SUBJECT: COMANCHE PEAK NUCLEAR POWER PLANT, UNITS 3 AND 4
DOCKET NUMBERS 52-034 AND 52-035
RESPONSE TO REQUEST FOR ADDITIONAL INFORMATION NO. 5585
(SECTION 9.4.5)

**Response to Request for Additional Information No. 5585 (CP RAI #213)
(Public Version)**

SRP SECTION: 09.04.05 - Engineered Safety Feature Ventilation System

Typical Missile Shield Drawing for Ventilation Openings

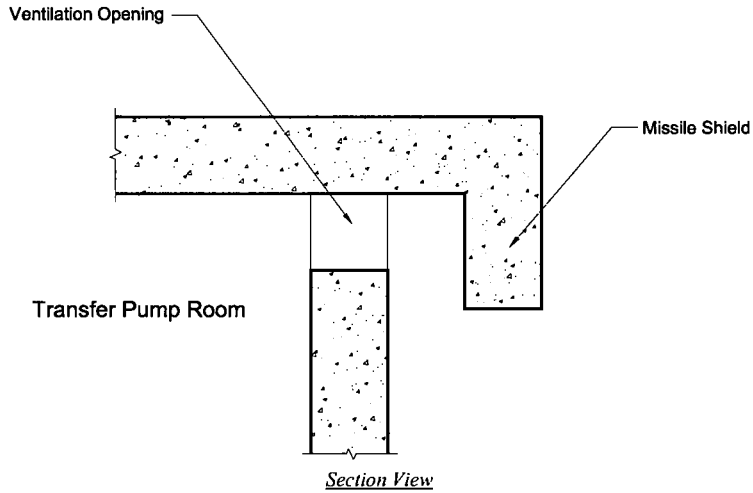
"The locations of the missile shields for the UHS ESW pump house are shown in the plan view of the UHSRS in FSAR Figure 3.8-206 at the northwest and southeast corners of each UHS ESW pump house. The missile shields for the transfer pump room air intake and exhaust openings are not shown in FSAR Figure 3.8-206. The locations of the ESW and transfer pump room ventilation opening missile shields are subject to change as detailed ventilation design and equipment layout progresses. FSAR Figure 3.8-206 and related Chapter 3 figures will be revised in a future FSAR Update Tracking Report as the detailed ventilation design and equipment layout progresses."

The staff cannot complete its review and close out this Open Item without bringing closure to this issue. Please state how missile protection will be provided for the ESW and transfer pump room ventilation openings.

Figure 3.8-206 has been revised to add a note clarifying that missile shields on the ventilation openings for the ESW pump room and UHS transfer pump room are provided. The location of the air supply intake and exhaust openings for the transfer pump room has been identified but the drawing has not been revised as of this time. The openings will be placed on the walls of the transfer pump room and missile shielding is provided for each opening by the reinforced concrete walls and roof slabs, which are thick enough to withstand missile impact loads and to prevent perforation and the potential generation of secondary missiles by spalling or scabbing effects. A typical drawing of the missile shield is shown below. The reinforced concrete walls and roof slabs surround all the ventilation openings and are

arranged to provide protection so there is no straight pathway for incoming missiles to enter through the ventilation opening.

Figure 9.4-201 UHS ESW Pump House Ventilation System Flow Diagram

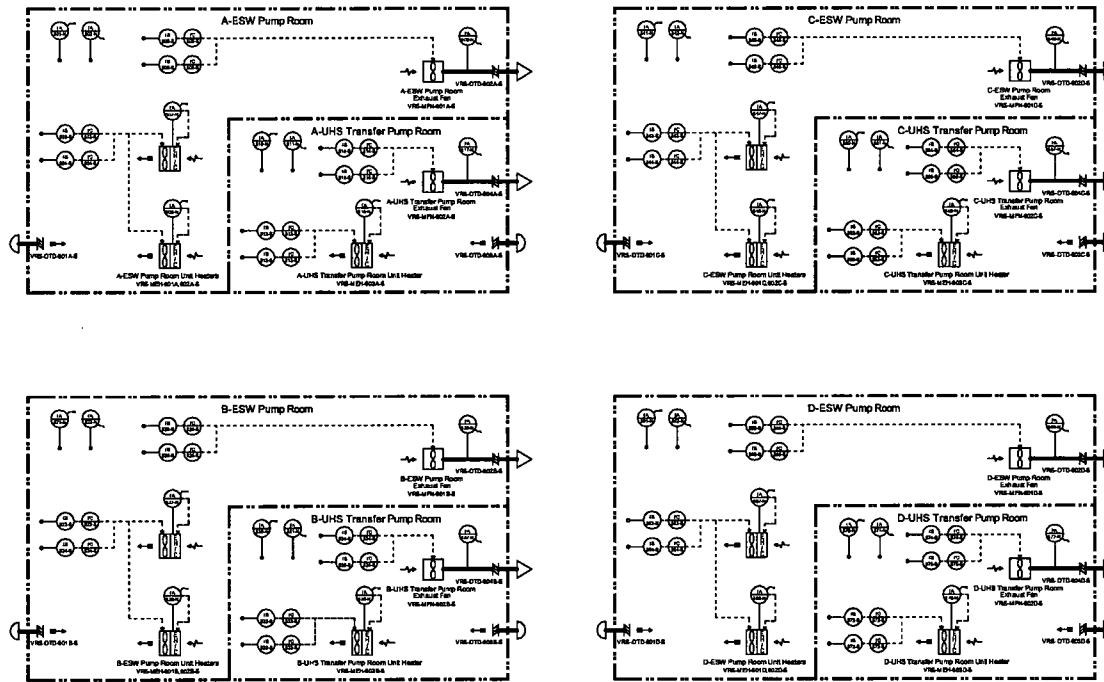
(3) The staff notes that the safety related temperature switches (e.g. VRS-TS-2610C,D,E,F) do not appear in FMEA Table 9.4-203. The staff requests that these safety related components be added to the Table 9.4-203.

- (2) The temperature switches (TSs) VRS-TS-803-S, 804-S, 805-S, 806-S (i.e., VRS-TS-2610C, D, E and F in COLA Rev. 1) and the associated temperature controllers (TCs) in question, VRS-TC-803-S, 804-S, 805-S, 806-S (VRS-TC-2610C, D, E and F in COLA Rev. 1) (for ESW Pump Room A) are safety-related. Temperature controllers located in series with their respective TSs, as shown in FSAR Figure 9.4-201, are part of a plant control system that starts/stops the associated heaters or exhaust fans. The plant control system used with safety-related components is the Protection and Safety Monitoring System (PSMS), which is a basic software program described in DCD Chapter 7 and incorporated by reference into the R-COLA. The signals from the TSs are transmitted to the PSMS, which provides the start or stop signal to the associated heaters and exhaust fans. This is the same design for all ESW pump rooms and UHS transfer pump rooms.

COLA Part 10 ITAAC Table A.2-2 is correct. Figure 9.4-201 has been revised to indicate that TCs are part of the plant control system.
